1992 - 1993 Corvette: Recall: Power Steering Gear Inlet Hose

Subject: PRODUCT SAFETY CAMPAIGN 93C02 - POWER STEERING GEAR INLET HOSE

Model and Year: 1992-93 CHEVROLET LT1 CORVETTE

Bulletin Number: 93C02

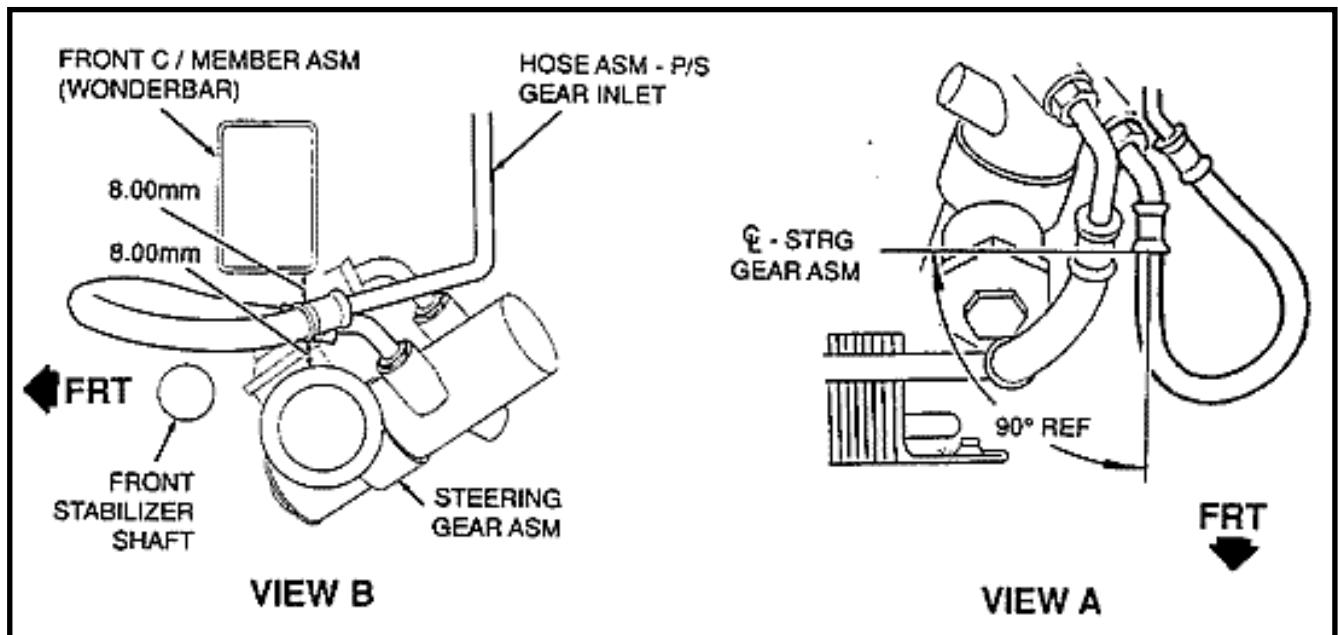
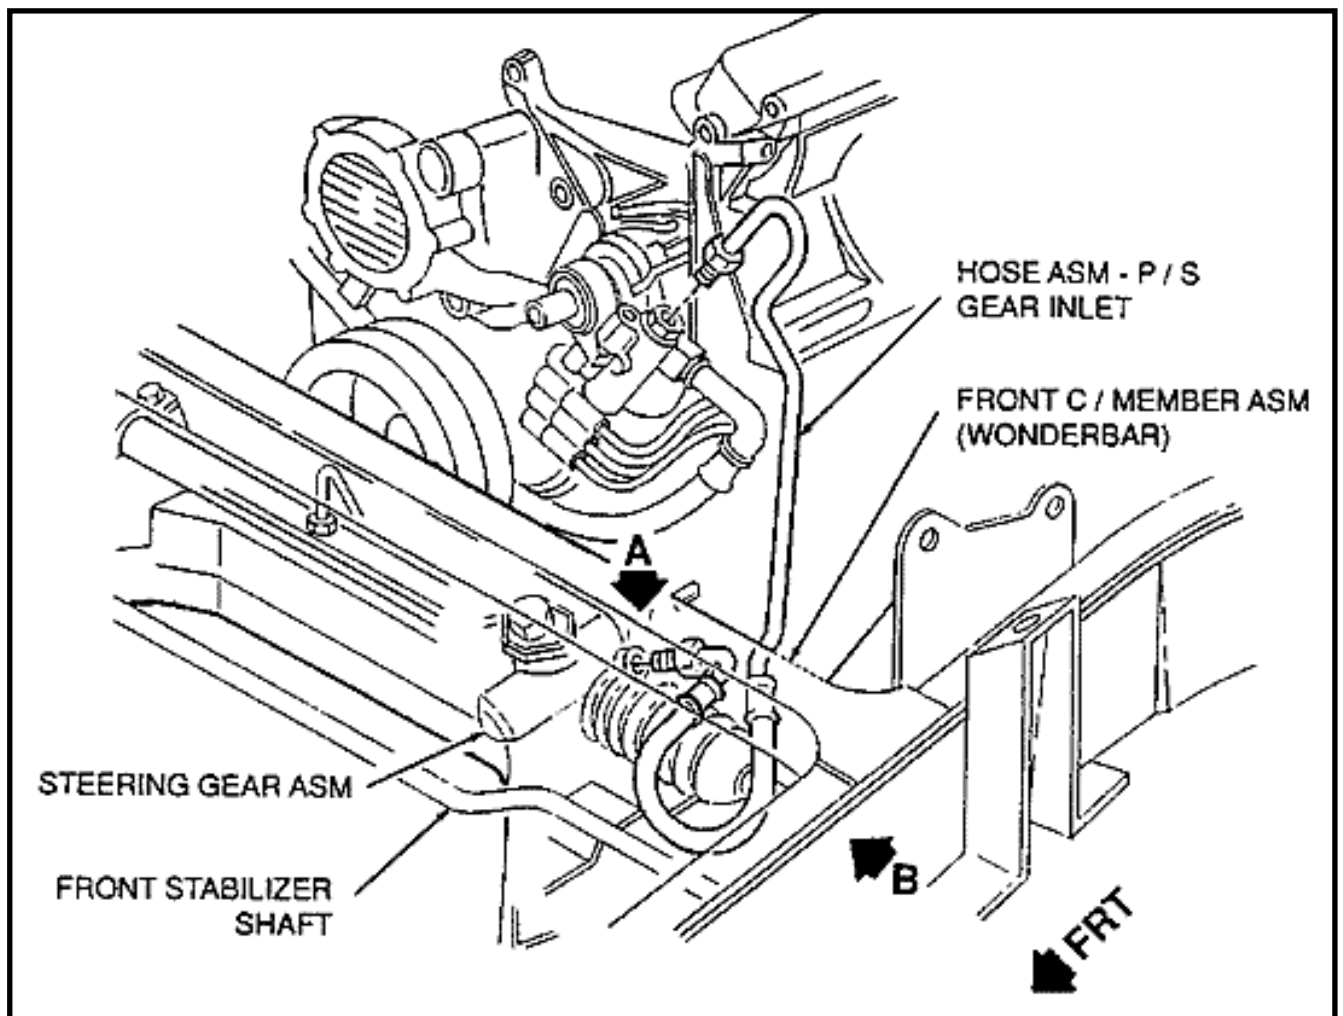
General Motors has determined that a defect which relates to motor vehicle safety exists in certain late 1992 and early 1993 Chevrolet Corvette model vehicles equipped with LT1 engines. These vehicles were assembled with a power steering gear inlet hose which may fracture. Since the fluid within this hose is under pressure, fracture of the hose could cause power steering fluid to spray out of the hose and, if an ignition source is present, an

To prevent this condition from occurring dealers are to replace the power steering gear inlet hose on involved vehicles.

Notice: Be certain to leave adequate clearance between front cross-member and hose/pipe assembly. View B on page 4 illustrates proper clearance.

1. Install new power steering gear inlet hose following procedures on page 3B-6 of either

the 1992 Corvette Service Manual (ST-364-92-1) or the 1993 Corvette Service Manual (ST-364-93PSID).
